Reference: 420 Fairhaven Road, Existing Garage to ADU conversion (B02440840)

Letter of Explanation/Justification

CONFIRMATION OF PRE-FILE

PRE-FILE #: 2025-0107-P
DATE: 11/20/2025
OPZ STAFF: Jennifer Lechner
I&P STAFF: Natalie Norberg

PROPOSED GARAGE TO ADU CONVERSION

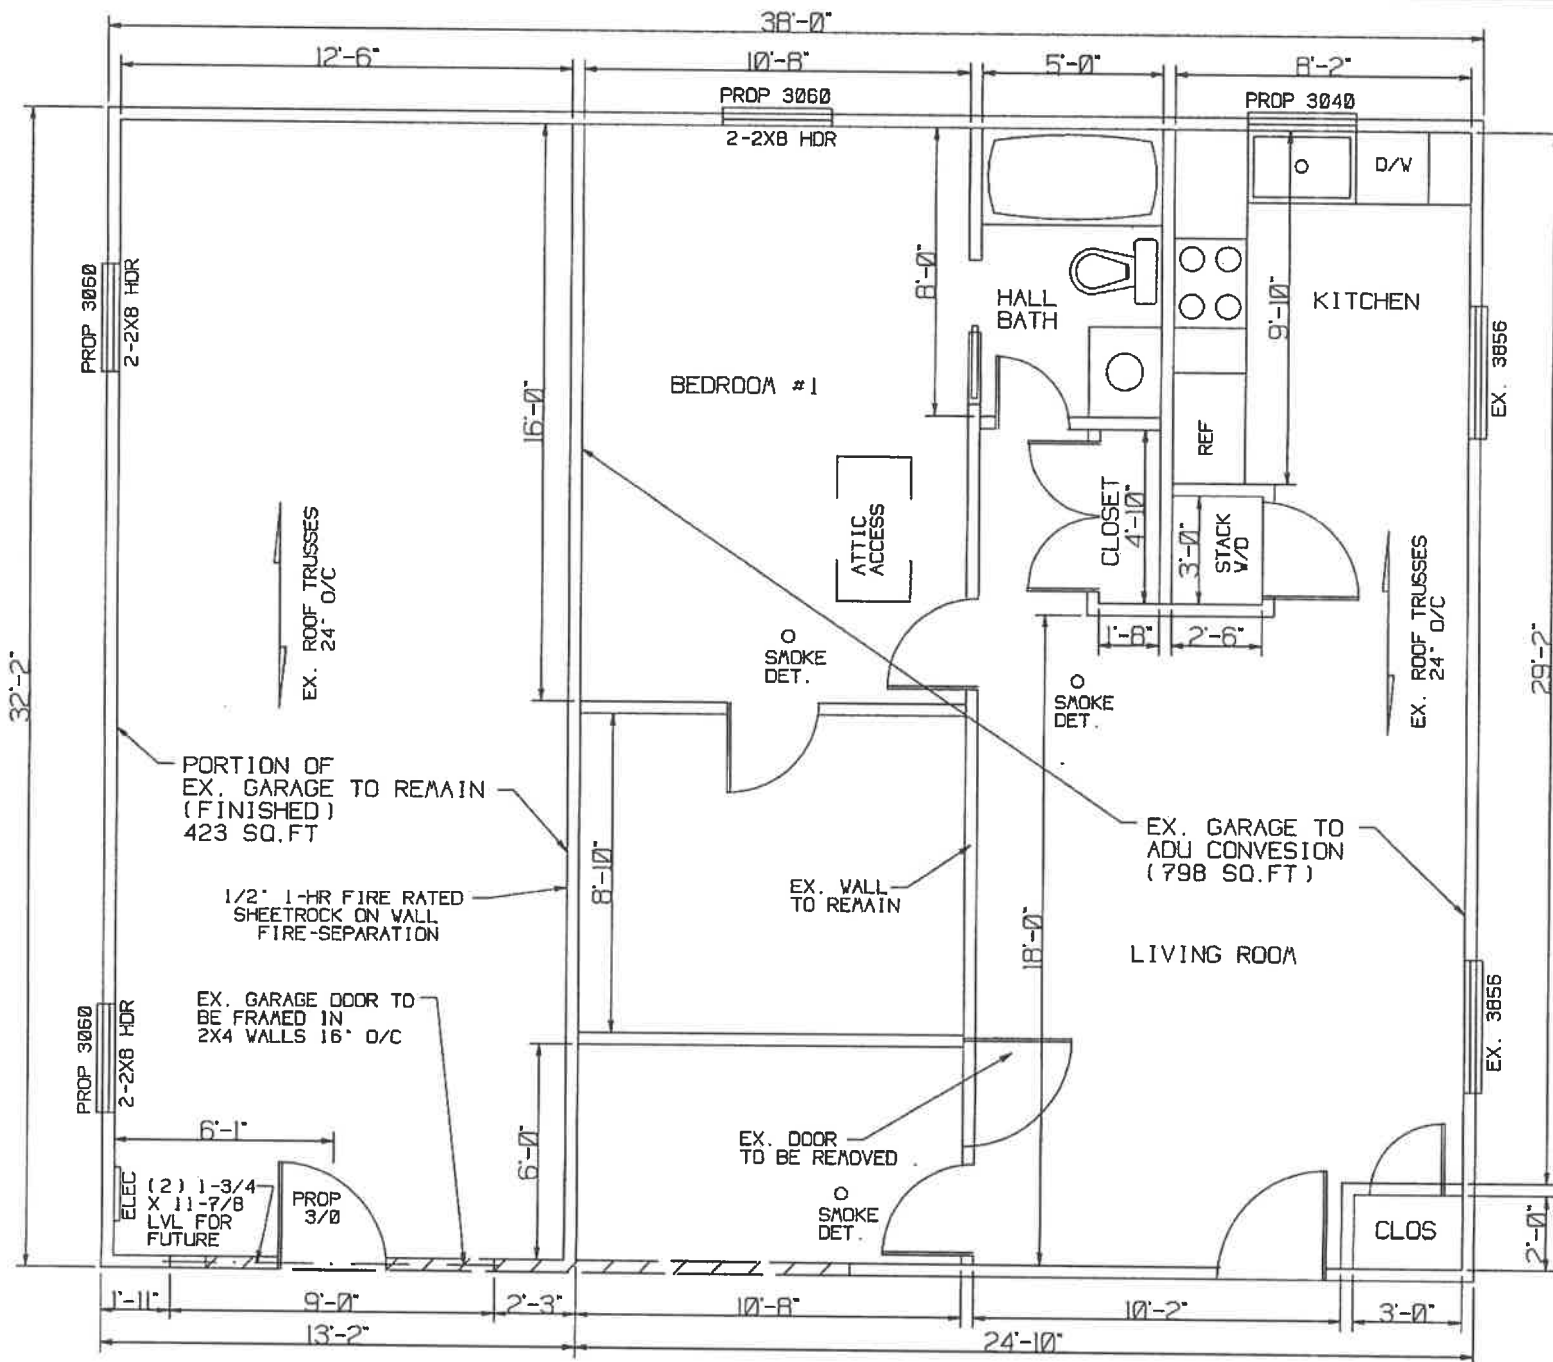
1. Revise the Administrative Site Plan to also include the dimensions of the existing garage (L x W x H).
2. The applicants are reminded that, in order for the Administrative Hearing Officer to grant approval of the variance, the proposal must address and meet all of the applicable variance standards provided under Section 18-16-305. The Letter of Explanation should address each of those standards and provide adequate justification for each of the variances required.

Zoning #1. We have added the dimensions of the existing garage to the site plan.
